Home Builders Association  
of Metropolitan Portland

Subject: Lot Size Averaging

The HBA of Metropolitan Portland appreciates the opportunity to comment on the proposed modification to the city's community development code, specifically the portion dealing with lot size averaging.

PRELIMINARY SUBDIVISION  
PLAT WITH BUILDING  
SETBACKS

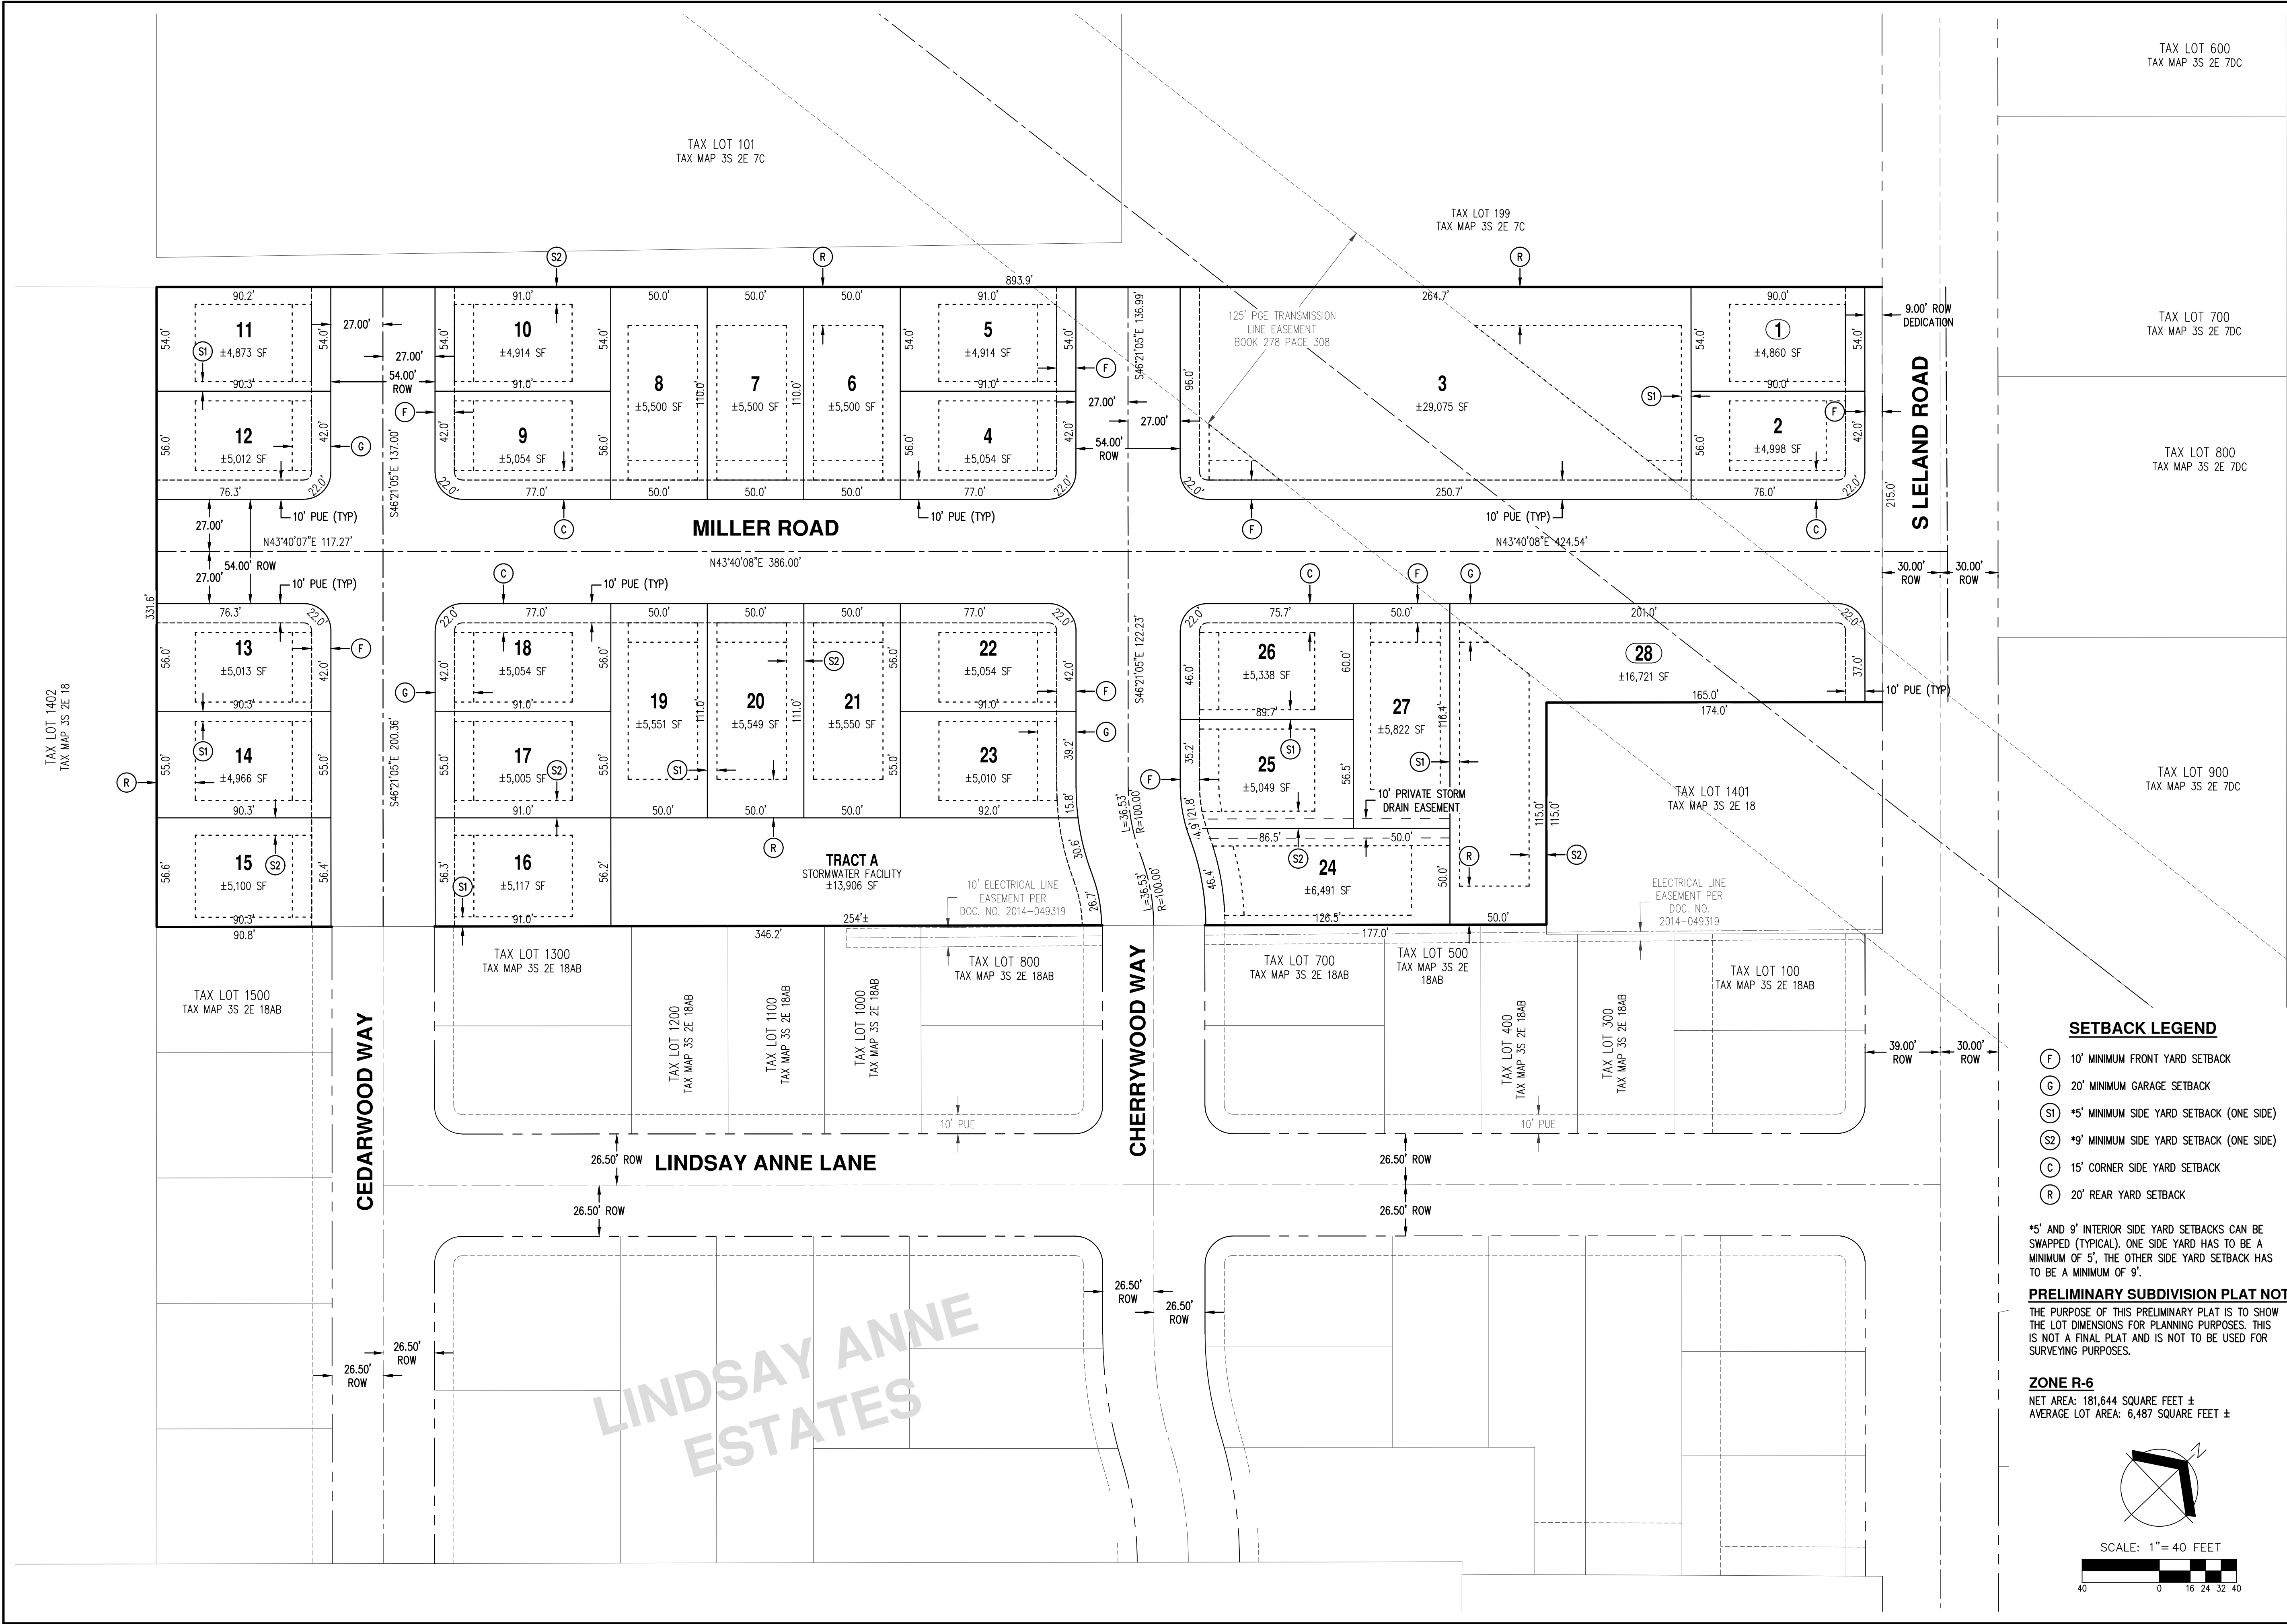
To summarize what was discussed at the stakeholder's meeting yesterday morning, if the draft code language was adopted by the City and effective and we didn't already have the Lindsay Anne Estates Too application in/approved, it would have reduced the density by 5 lots. See attached. It wouldn't meet the City's minimum density requirement unless the PGE easement was taken out of the site's net developable area for the calculation.

We also discussed looking at other potential layouts of Lindsay Anne Estates Too. After looking into it, changing the "Up to 25% of the lots in a subdivision..." to 50% or all (100%) would not have affected this layout as only two of the lots were less than 6,000 S.F.

If the 125' wide PGE easement was taken out of the site's net developable area for the calculation (and considered unbuildable), lots 3 and 28 would be negatively affected.

It is the change of the code from twenty percent less than the required minimum lot area to ten percent less that would have reduced the number of lots on this project by 5 lots.
